## 2. 11 Mall Road - Game On & Loretta's Last Call

## **PLANNING BOARD AGENDA FOR JANUARY 13, 2026 - 7:00 PM**

1. **Salem NIM, LLC Site Plan** – Public Hearing for change of use for 19,960 sq. ft. restaurant and entertainment use with conditional use permit for reduced parking and additional signage at 11 Mall Road, Map 107, Lot 11154. Continued from 12/9/2025.

# LYONS GROUP RESTAURANT AT THE MALL AT ROCKINGHAM PARK PLANNING BOARD SUBMISSION

VT901

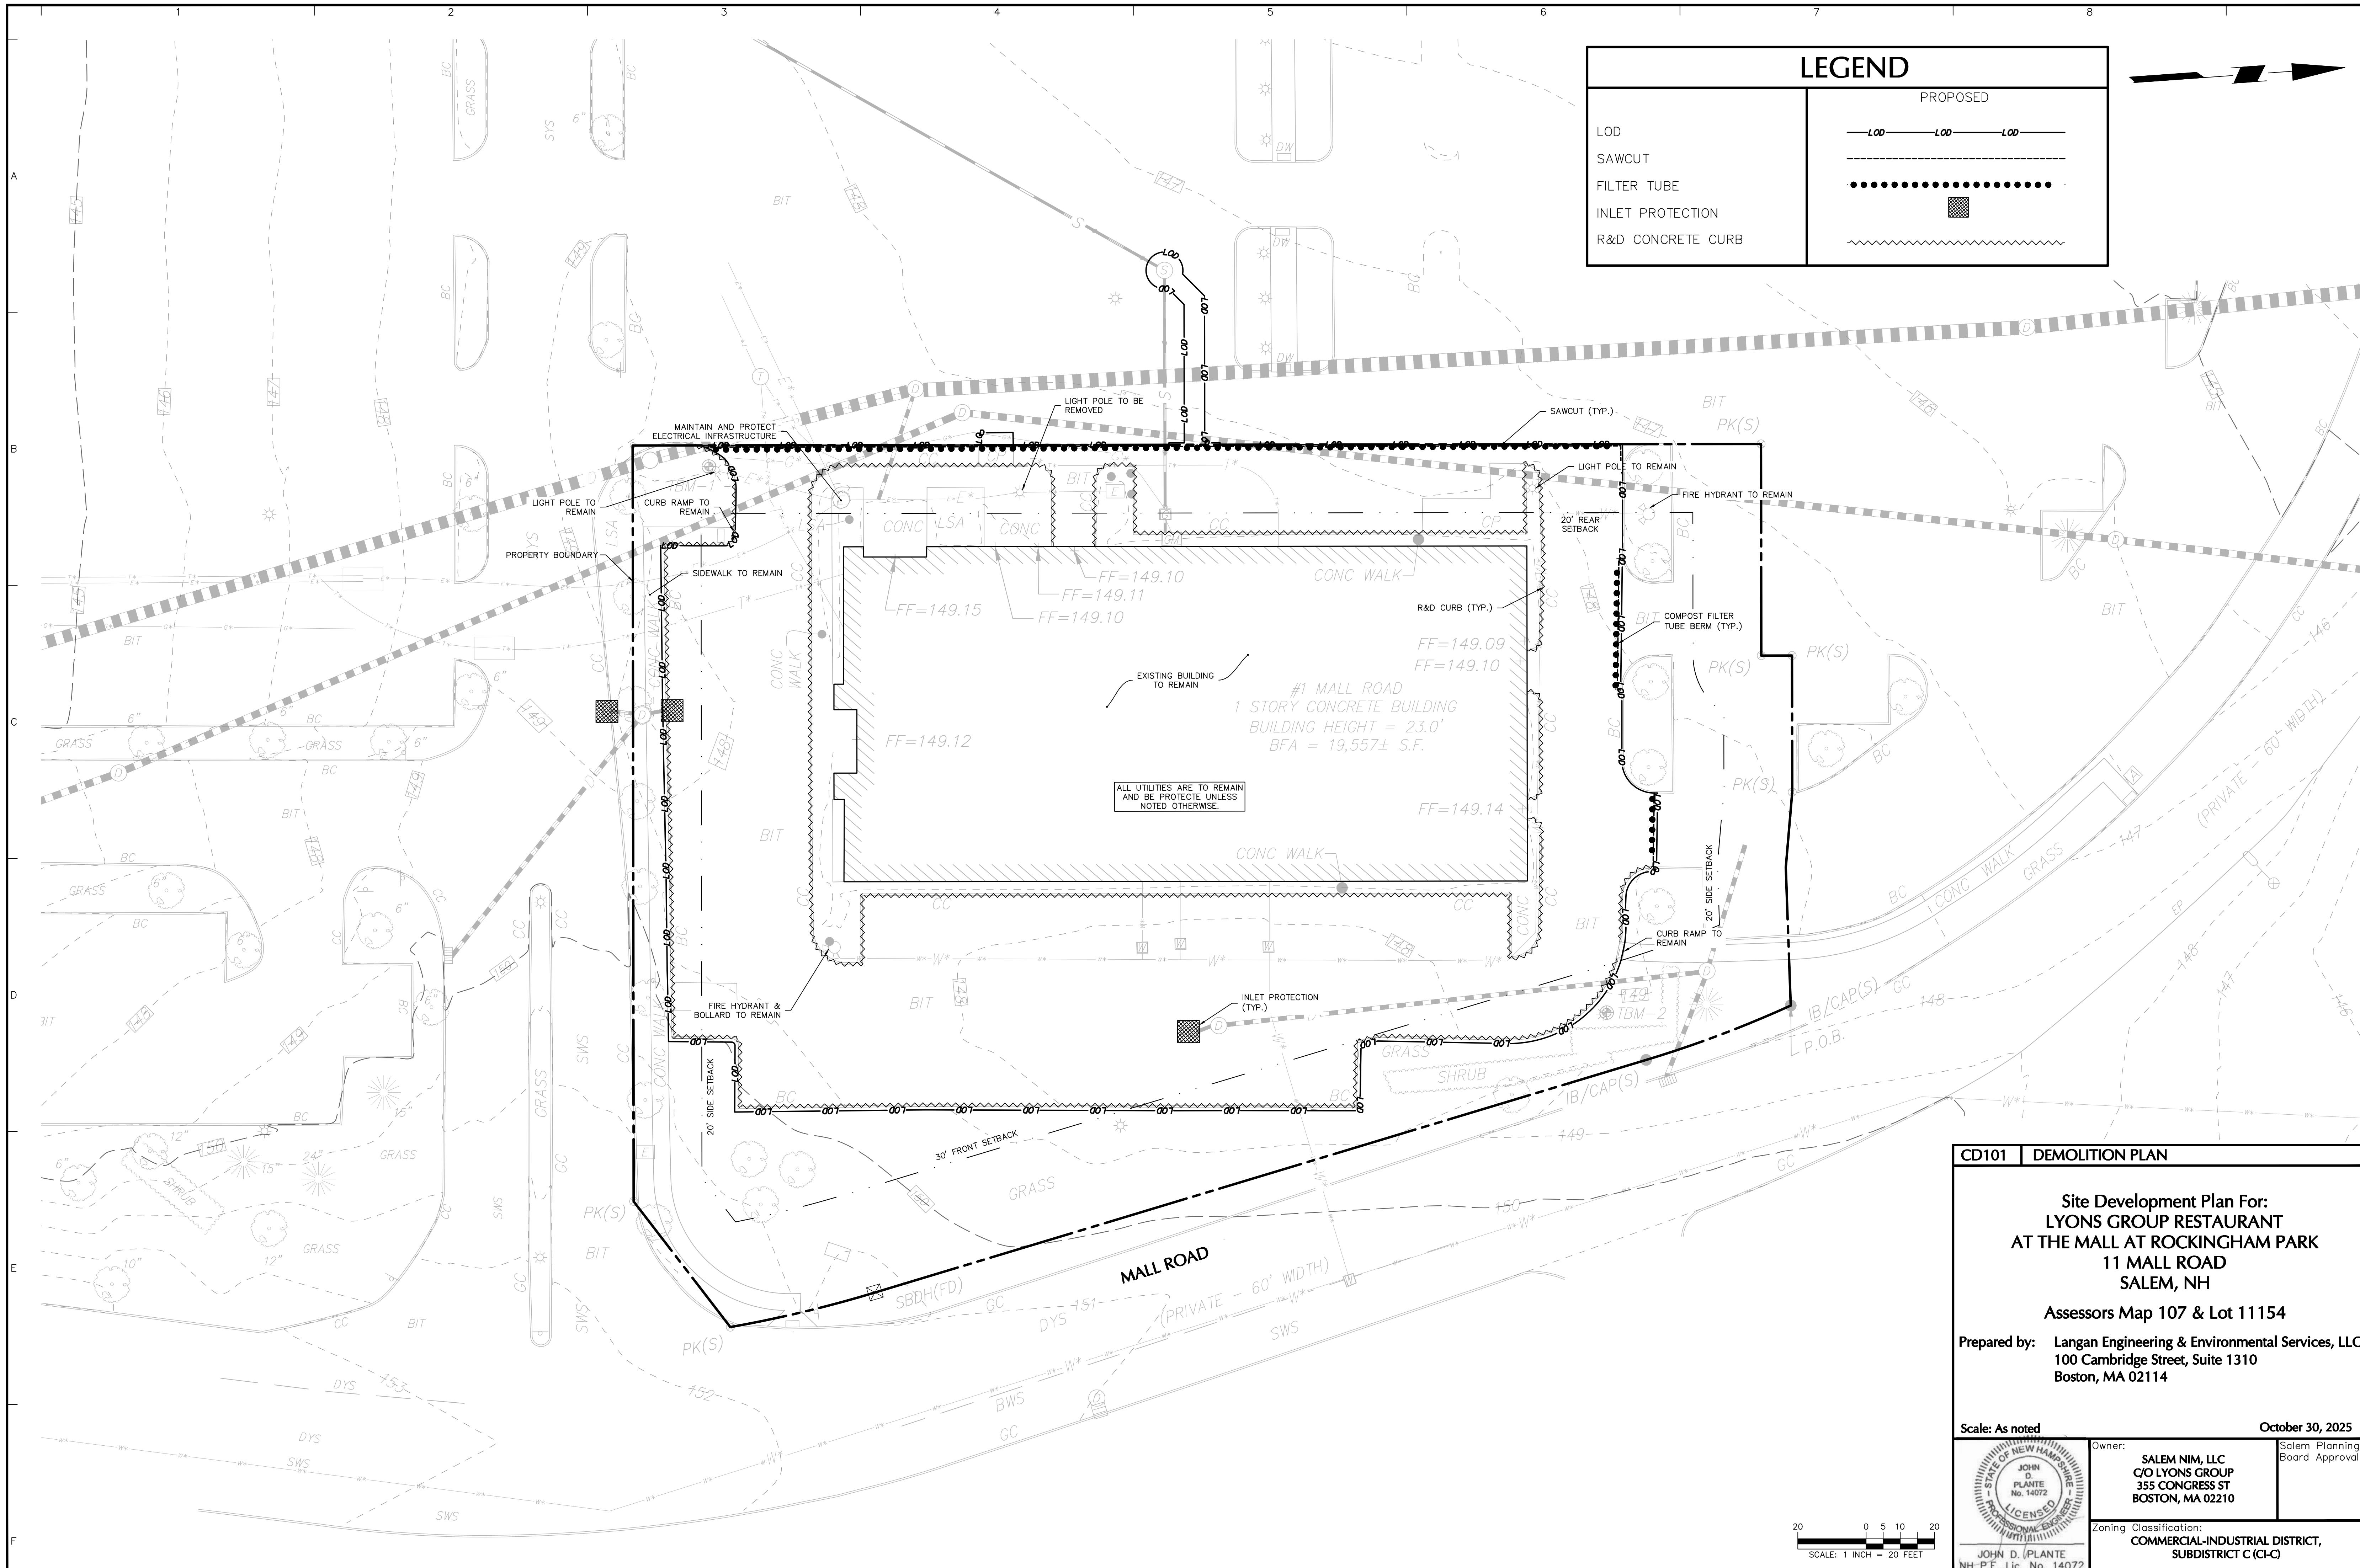
- Eliminate zoning table on Existing Conditions Plan

**COMMENT RESPONSE:** Zoning Table has been removed from VT901.

M101 | GARBAGE TRUCK MOVEMENT PLAN

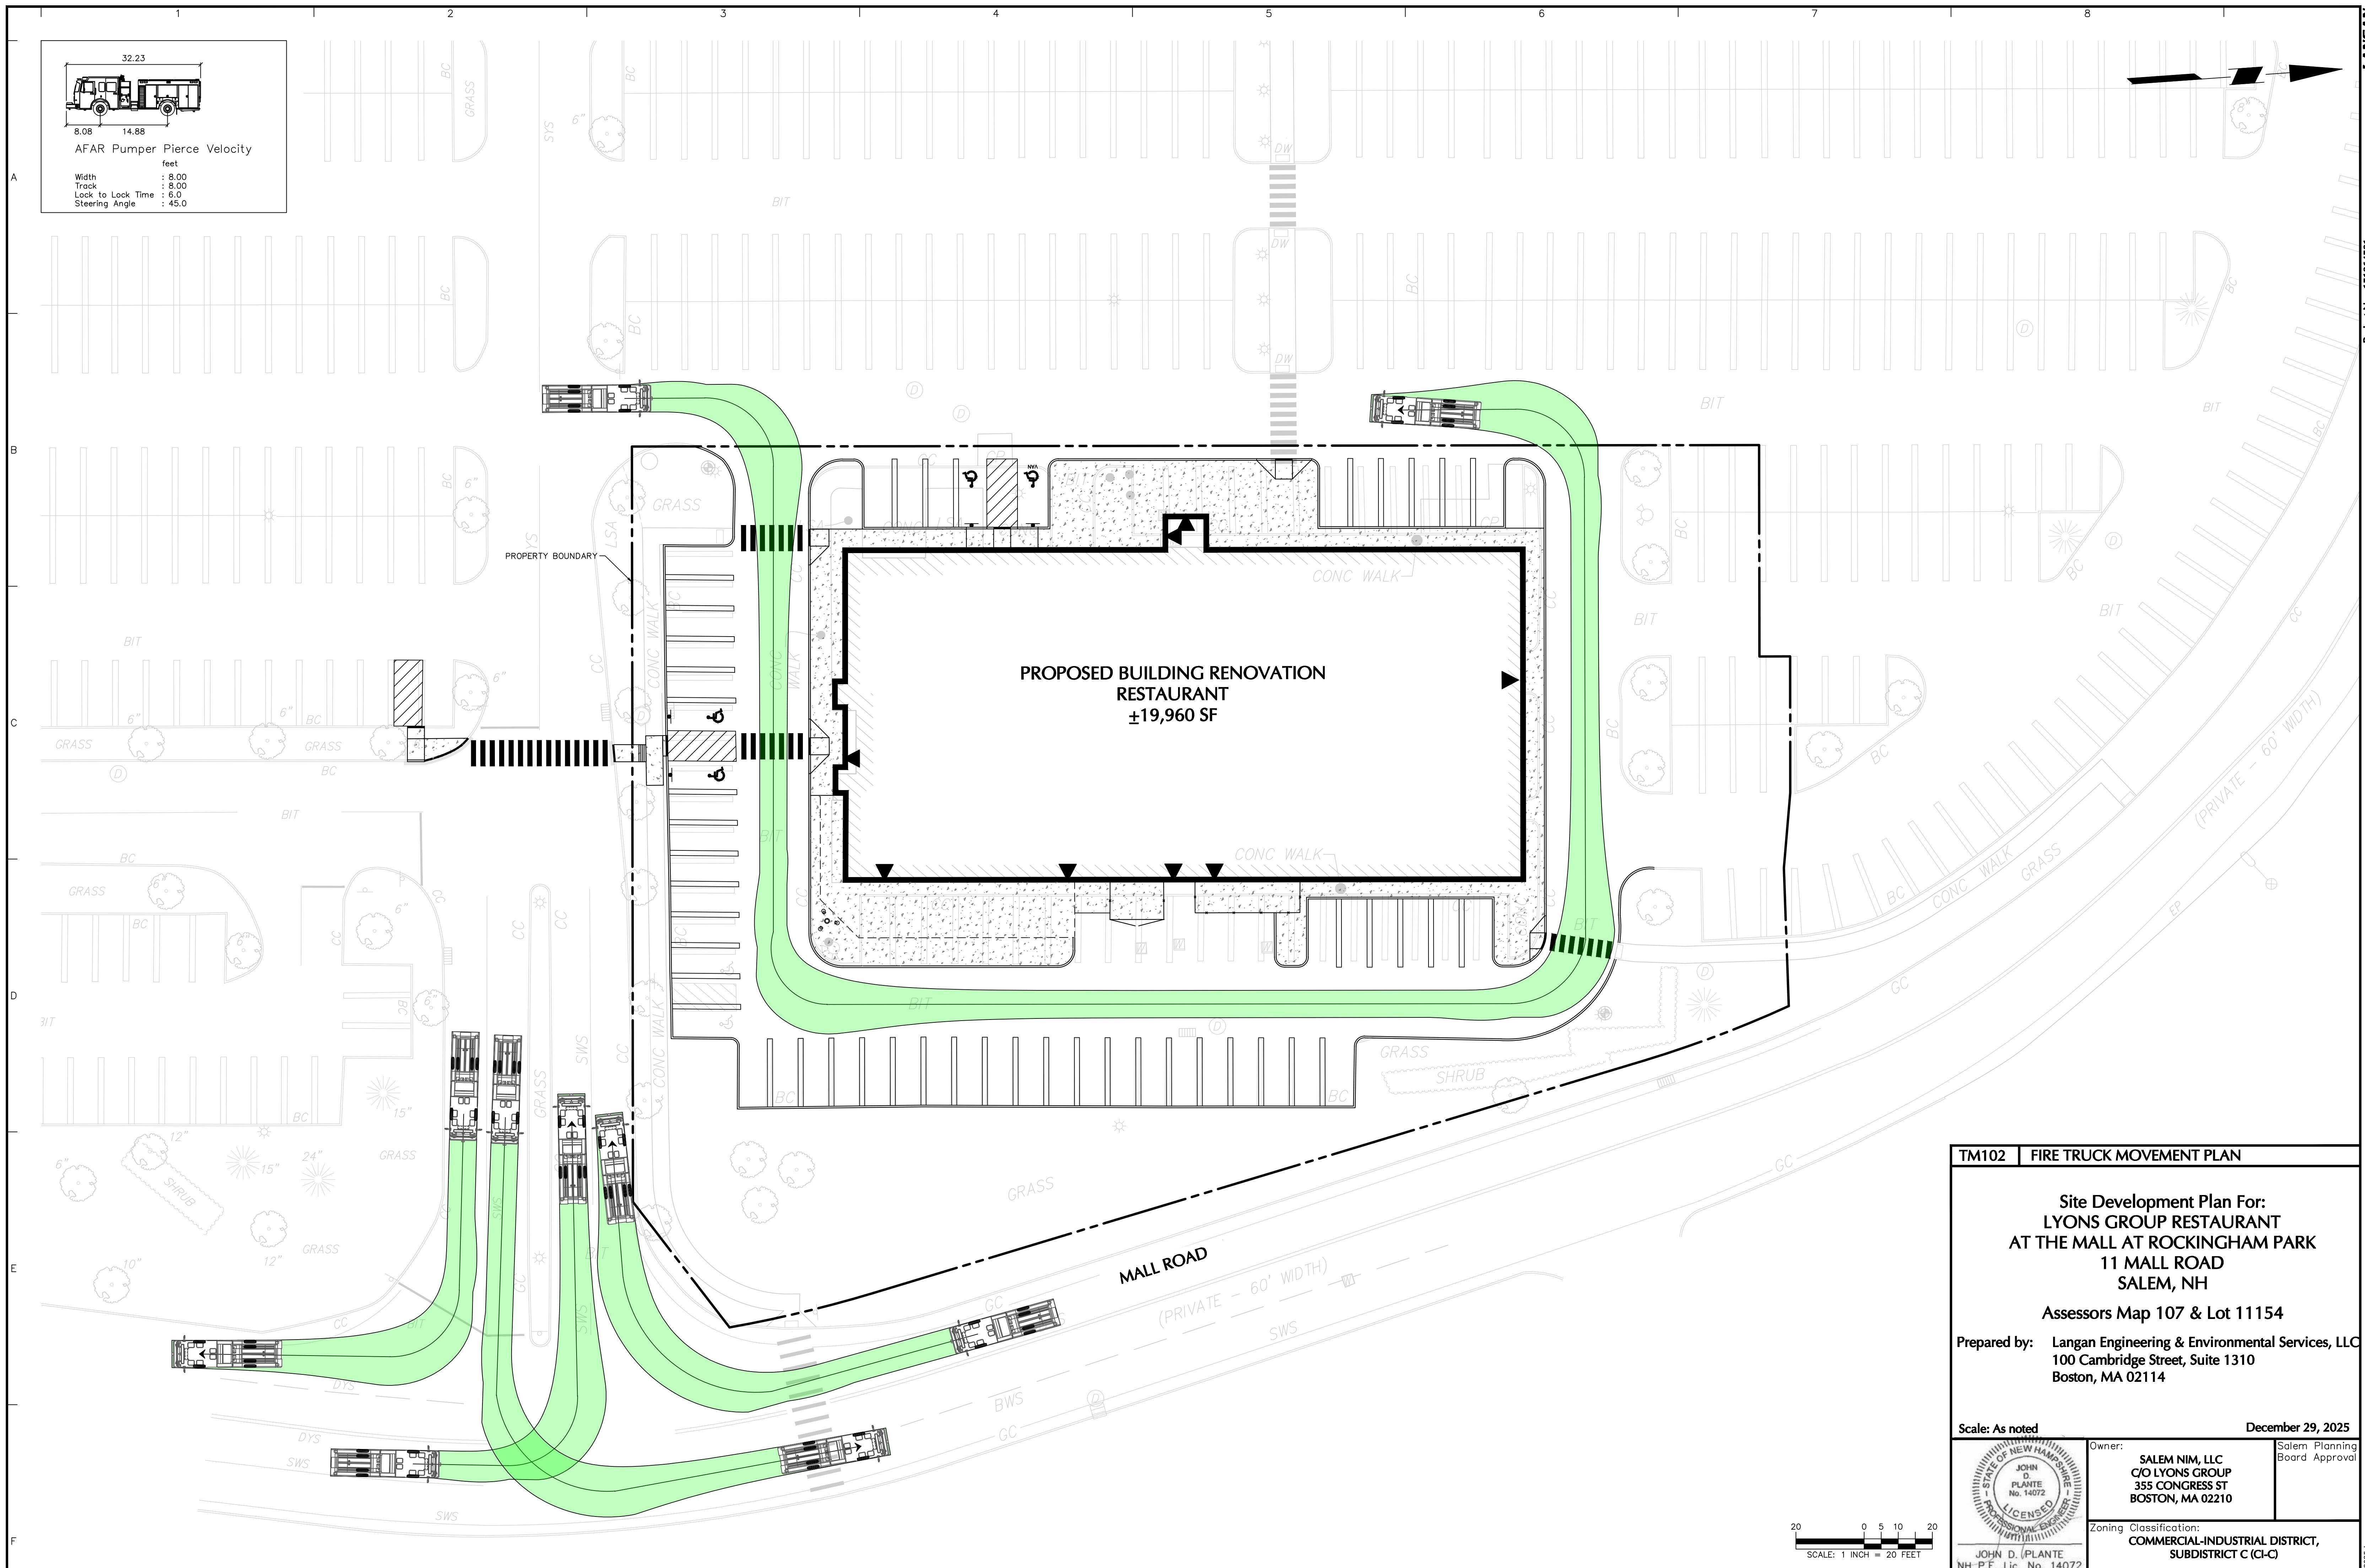
COMMENT RESPONSE: Southern sidewalk now has a connection to the parking lot. This sidewalk connects to a crosswalk to cross at the intersection where they can head north to other pathing.
  - Submit truck turn plan for trash pickup

COMMENT RESPONSE: Truck turning plan has been added to the set on TM101.

FM102 FIRE TRUCK MOVEMENT PLAN

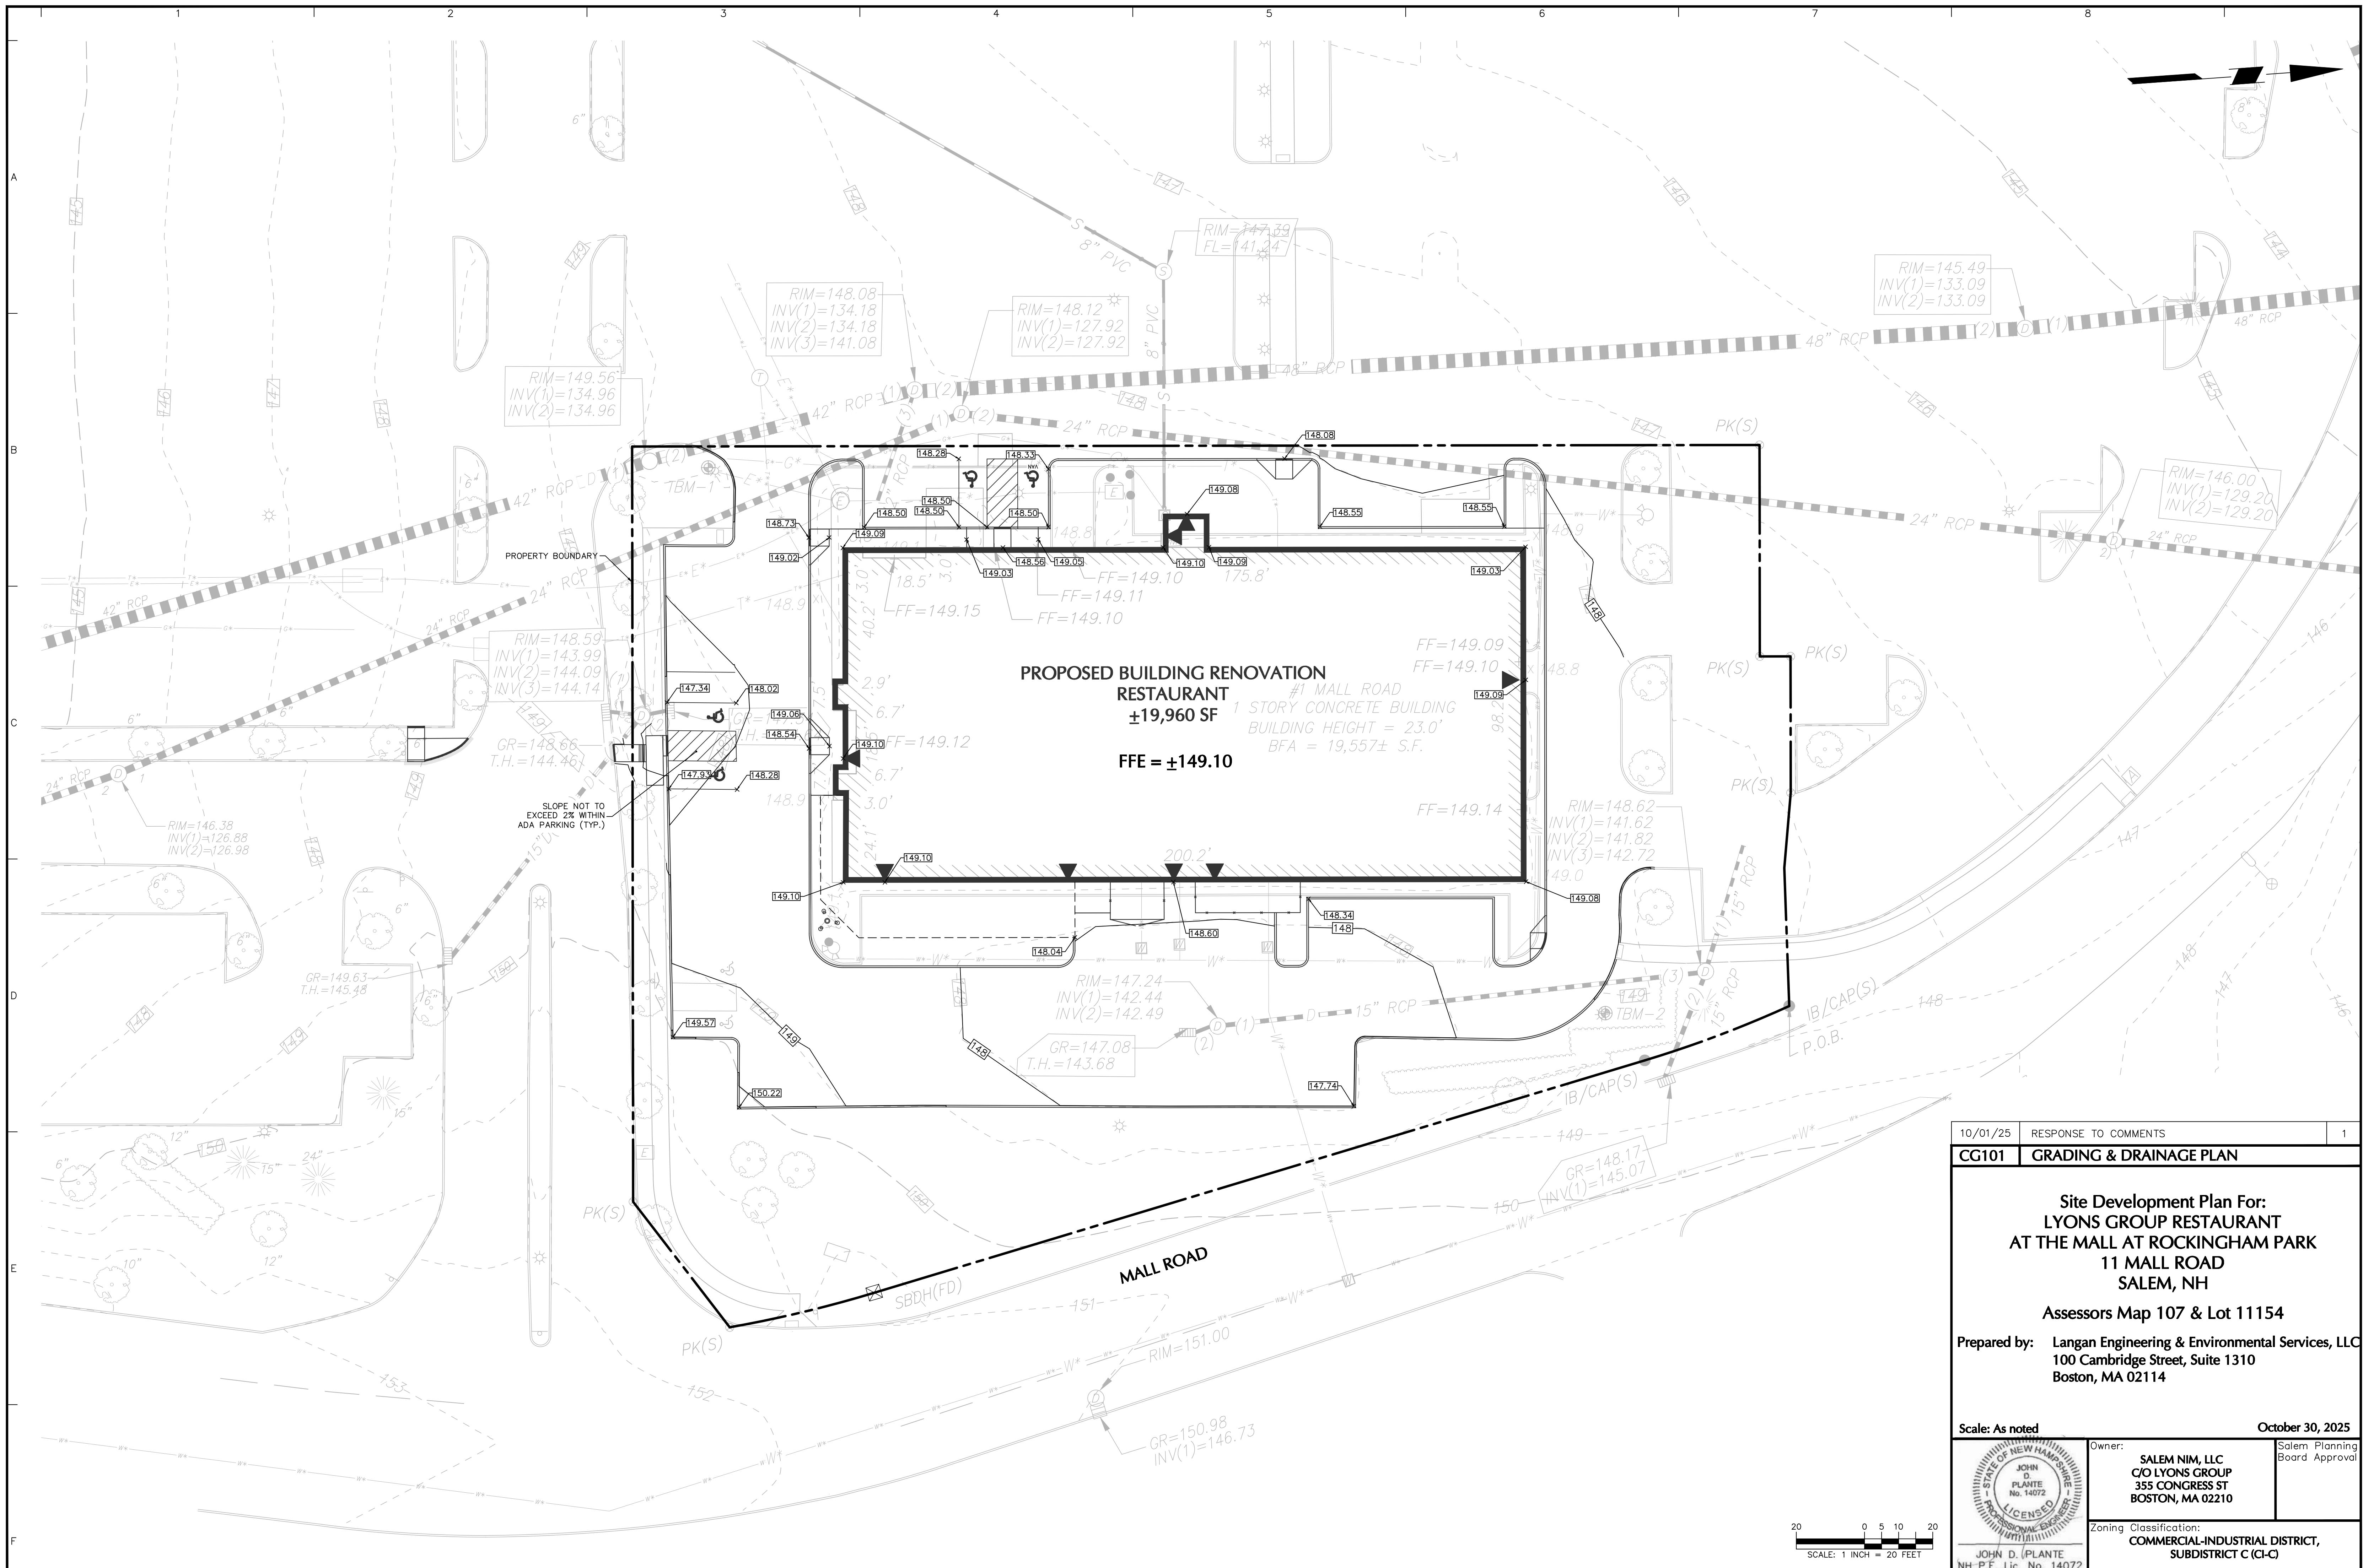
Site Development Plan – A vehicle tracking analysis should be prepared that demonstrates: 1) compatibility with Salem fire apparatus, and 2) how the dumpsters will be serviced. According to Sheet CS101, 68 spaces are proposed within the subject site. It should be noted that the peak parking demand estimates range from 158 to 395 occupied spaces. This means that there is the

**COMMENT RESPONSE: Vehicle turning movement demonstrations are provided on Sheets TM101 and TM102. The 85<sup>th</sup> percentile (peak) parking estimates for Loretta's and Game On! are 266 spaces, which is 71% of the available parking spaces within Lot C1.**
